File # ZON2005-00230 SUB2005-00018

SUBDIVISION STAFF REPORT Date: February 17, 2005

DEVELOPMENT NAME McMurray Place

SUBDIVISION NAME McMurray Place Subdivision

SITE PLAN

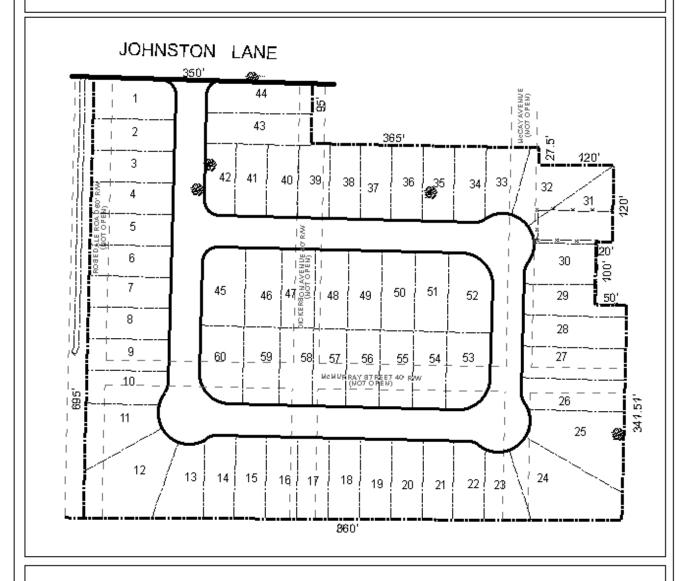
COMMENTS No common area shown for stormwater detention.

Significant existing stormwater problems downstream from proposed development. MINIMUM requirements will be detention for a 100 year storm with a 10 yr release rate and possible downstream system upgrades. Must comply with all stormwater and flood control ordinances. Any work performed in the right of way will require a right of way permit.

In general, the PUD meets the requirements for PUD approval. However, it should be noted that the modified grid pattern of the proposed development lends itself to connection to the existing rights-of-way of either McCay Avenue to Johnston Lane or McMurray Street to Schaub Avenue. Either of these connections would not only help preserve the existing grid pattern that is prevalent in Pinehurst, but would also afford a second point of access for the development.

RECOMMENDATION Planned Unit Development: based on the preceding, it is recommended that this application be approved subject to the following conditions: 1) construction of a connection of the existing right-of-way of either McCay Avenue to Johnston Lane or McMurray Street to Schaub Avenue; 2) completion of the vacation process for existing rights-of-ways within the proposed subdivision; 30 compliance with City Engineering Comments (Significant existing stormwater problems downstream from proposed development. MINIMUM requirements will be detention for a 100 year storm with a 10 yr release rate and possible downstream system upgrades. Must comply with all stormwater and flood control ordinances. Any work performed in the right of way will require a right of way permit); and 4) full compliance with all municipal codes and ordinances.

conditions: 1) construction of a connection of the existing right-of-way of either McCay Avenue to Johnston Lane or McMurray Street to Schaub Avenue; 2) completion of the vacation process for existing rights-of-ways within the proposed subdivision; and 3) compliance with City Engineering Comments (Significant existing stormwater problems downstream from proposed development. MINIMUM requirements will be detention for a 100 year storm with a 10 yr release rate and possible downstream system upgrades. Must comply with all stormwater and flood control ordinances. Any work performed in the right of way will require a right of way permit).
